**ADDENDUM REPORT
ON**

**TEMPORARY ACCESS ROAD
MISSISSIPPI RIVER WETLANDS
HIGHWAY 417
W.P. 451-90-03/04
ARNPRIOR, ONTARIO**

December 1999

FIGURE 1

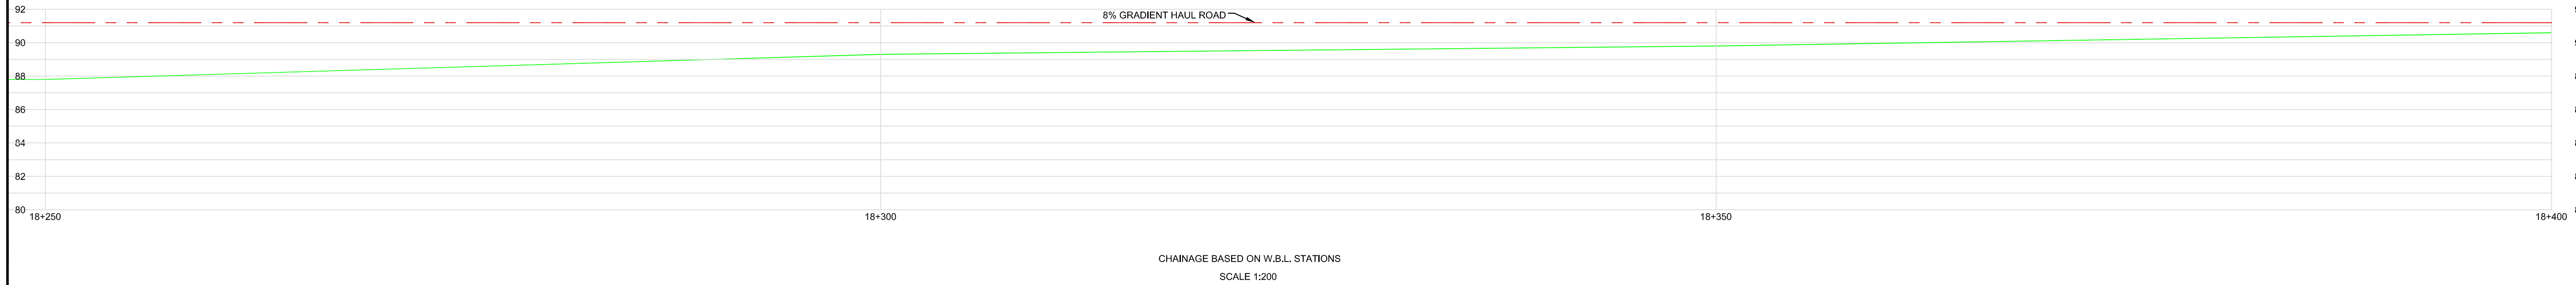
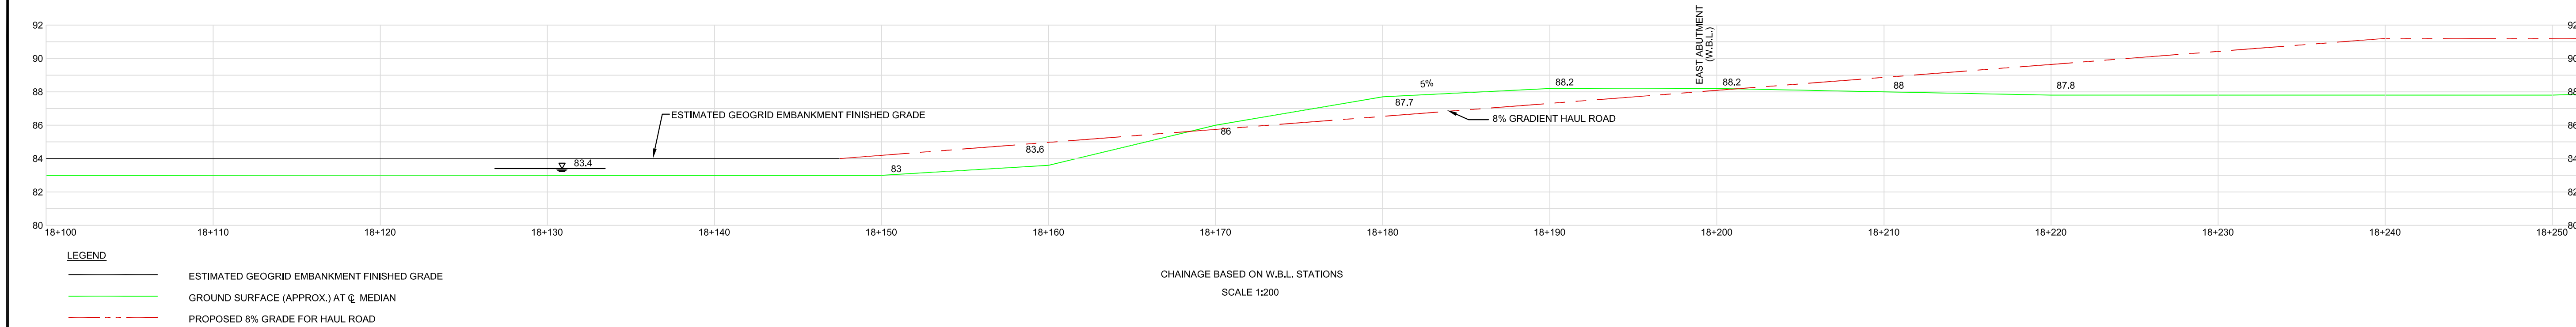
For the proposed 8% gradient for the 8 m wide haul road, fills up to 1.5 m high in the median are required as shown on Figure 1. Some adjustments with regard to fill heights will be necessary during the final design / construction period to facilitate any overlap between the geogrid

To develop an 8% gradient from Station 18+170 WBL to Station 18+200 WBL cuts up to 1.1 m will be required as shown on Figure 1. Thurber boreholes (#95-6 #95-7, #95-13, #95-14, #99-4 and #99-5) reveal the presence of a very stiff desiccated silty clay crust in the order of 3.0 m to 5.0 m in thickness with undrained shear strength in excess of 100 kPa. Since highway embankments are not required in this area, the 8.0 m wide haul road can be constructed in cuts 1 to 2 m in height to the grades shown on Figure 1 with 1.5H:1V or flatter side slopes without any stability problems. During the construction of the haul road, if necessary, biaxial geogrid and geotextile may be used to prevent rutting of the road surface.

CROSS SECTION AT
STATION 18+220
(WESTBOUND STATIONS)

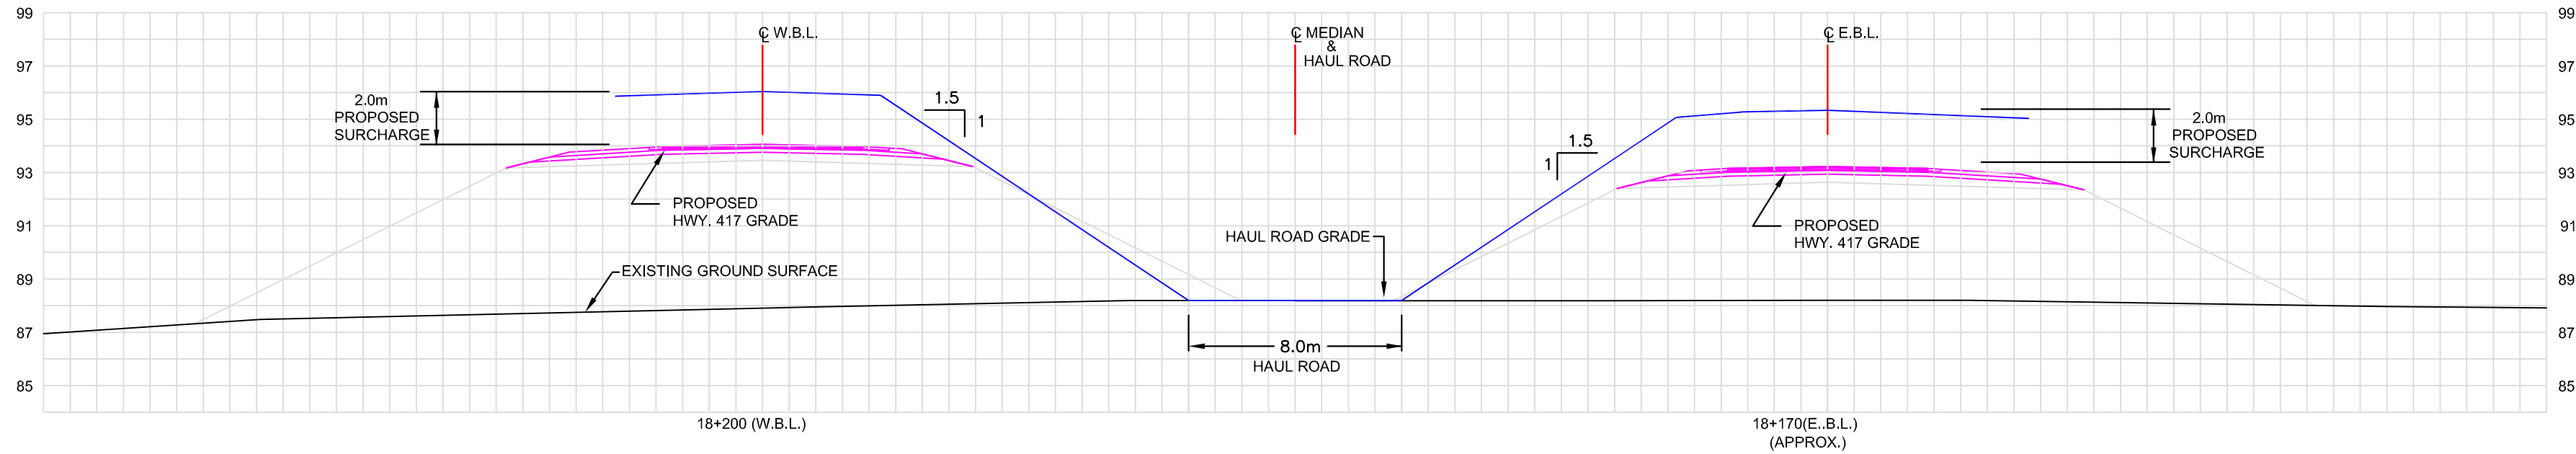
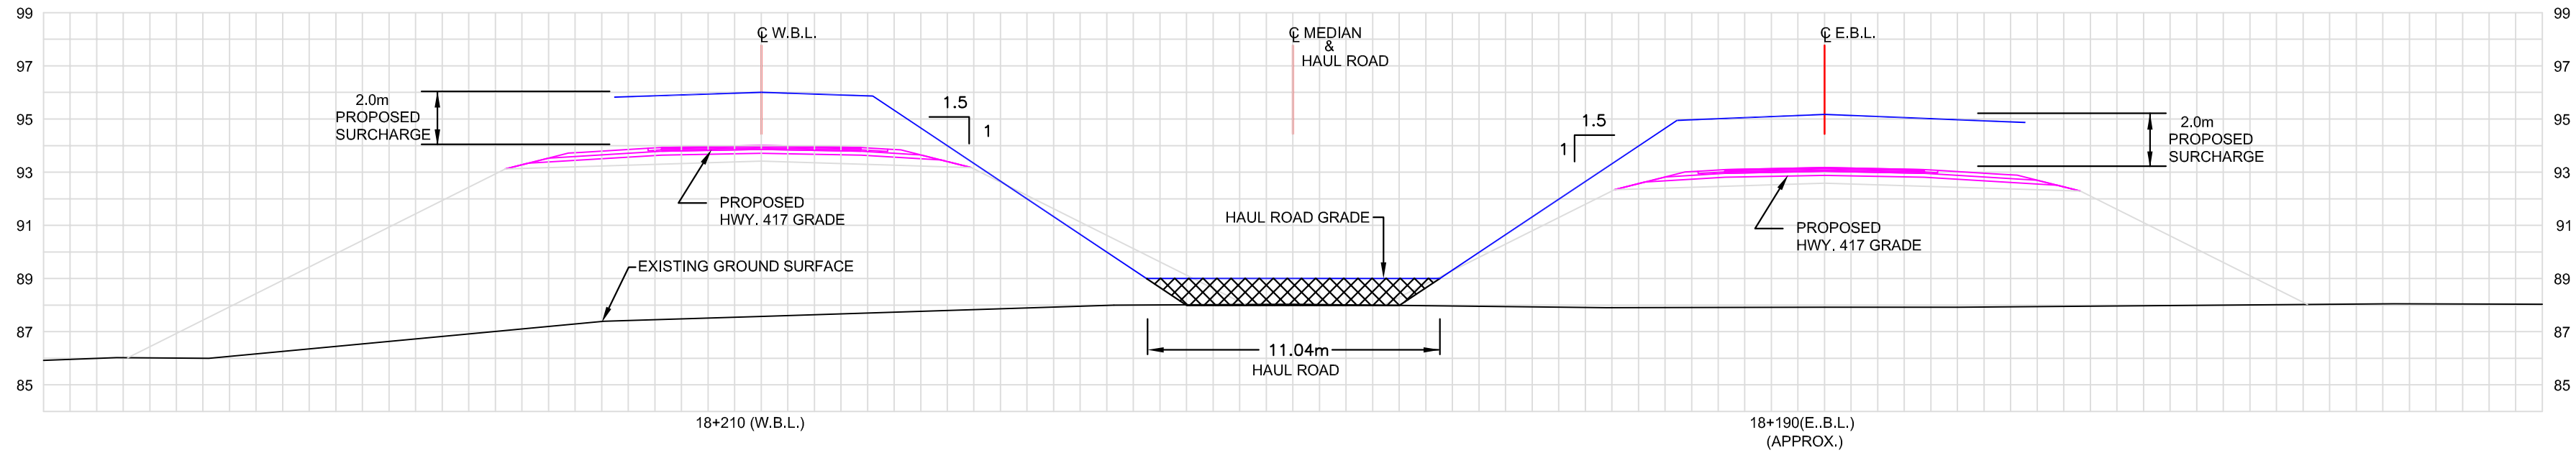
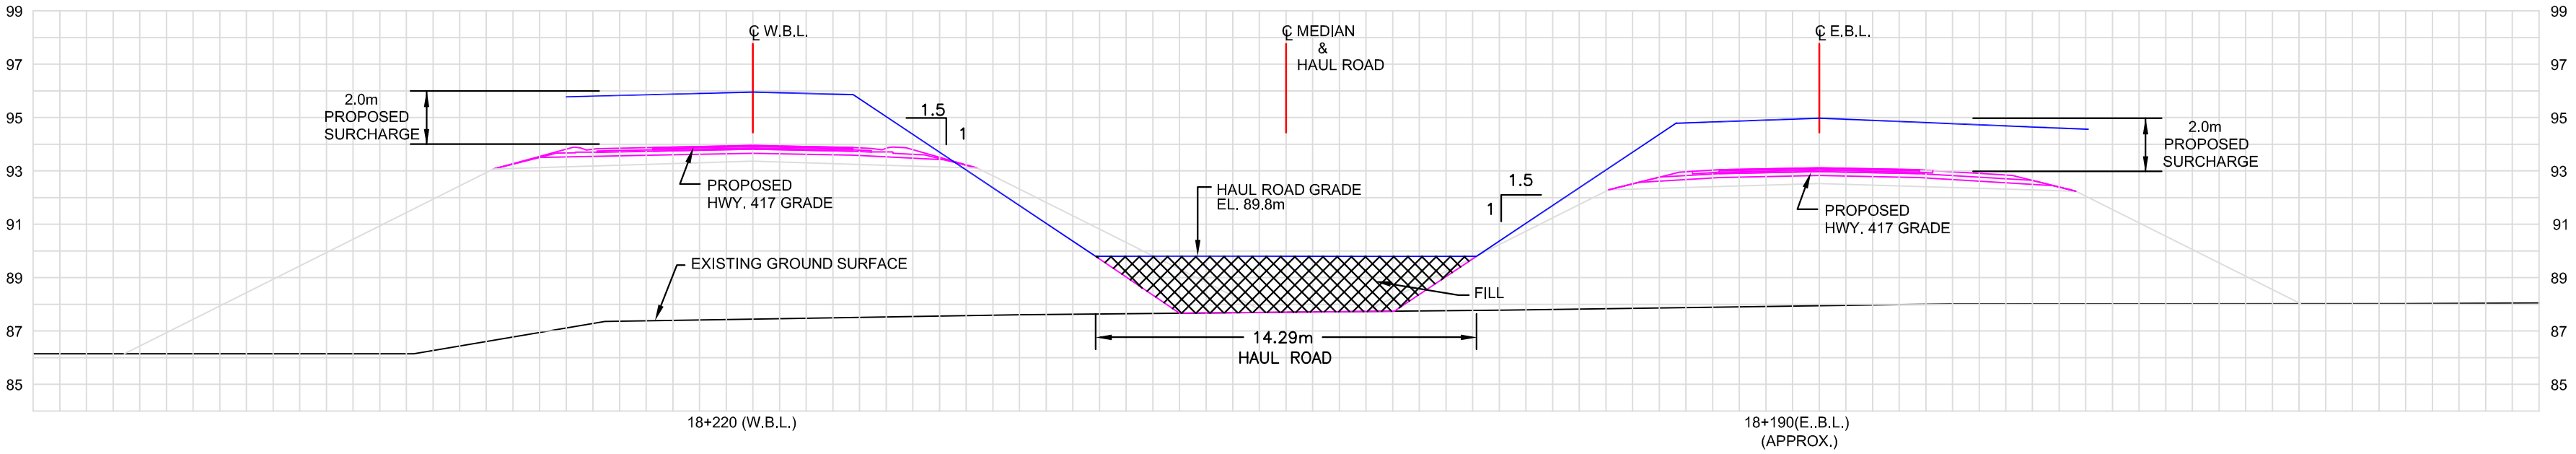
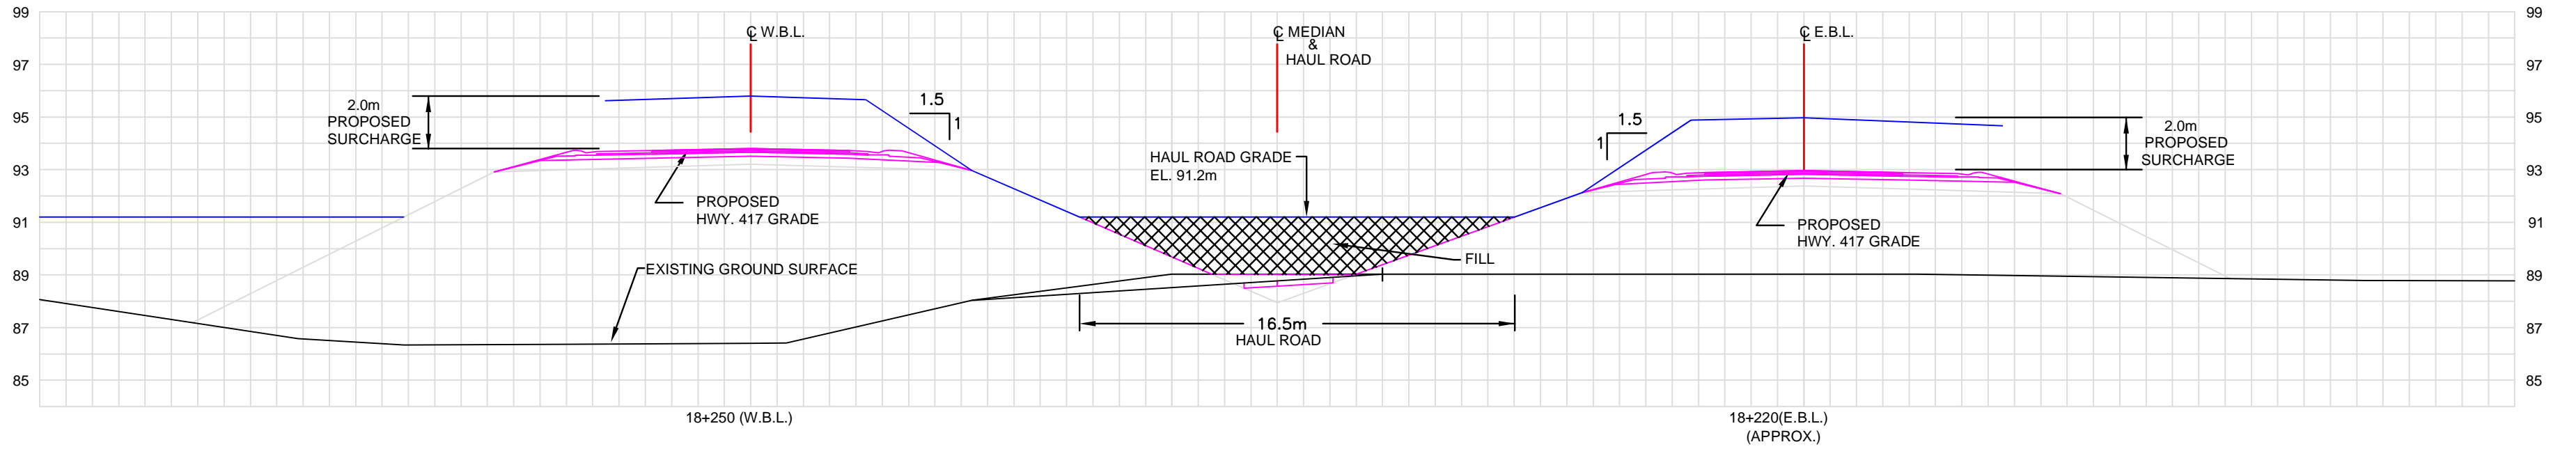
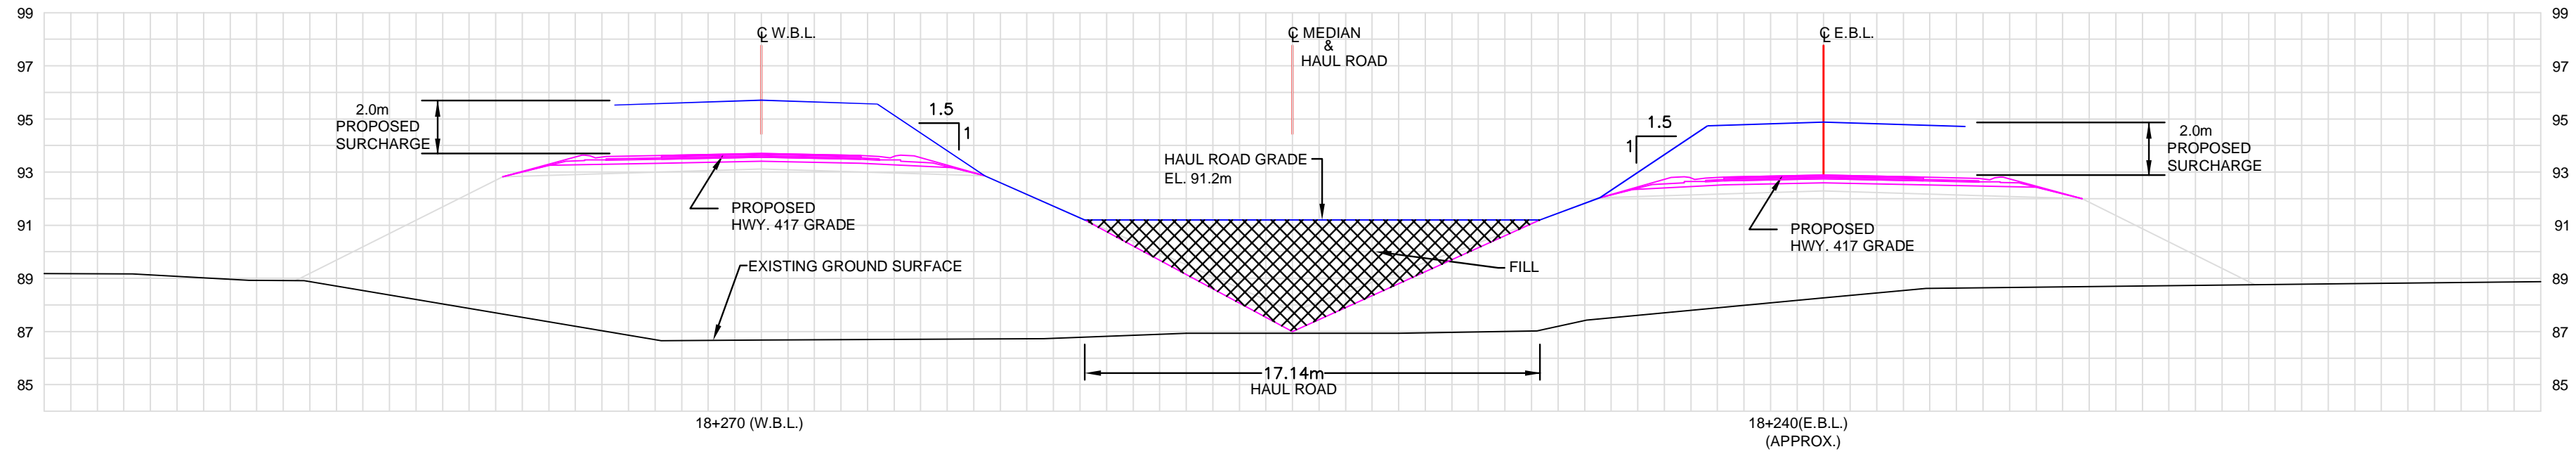
If the access road is to be at original ground surface at and behind the abutments, it will be necessary to steepen the embankment side slopes to 1.5 horizontal to 1.0 vertical (refer to Figures 2, 3 and 4).

A preliminary assessment of stability of the temporary slopes of 1.5 horizontal to 1.0 vertical was carried out using Thurber's borehole data in the area of the proposed abutments. The assumptions for the stability analysis are as follows:

Based on the preliminary analyses it is concluded that the temporary slopes of 1.5 horizontal to 1.0 vertical are stable with a factor of safety of 1.5 for a deep seated failure surface. Slope protection measures are necessary to prevent surficial erosion of these steeper slopes by means of hydroseeding and covering with an erosion control blanket. Our analyses also indicate a factor of safety of 1.7 for embankments constructed with 2 horizontal 1 vertical to the above mentioned height and assumptions for a deep seated failure surface. Our analysis does not take into consideration the effects of wick drains on any increase in the shear strength of the clay.
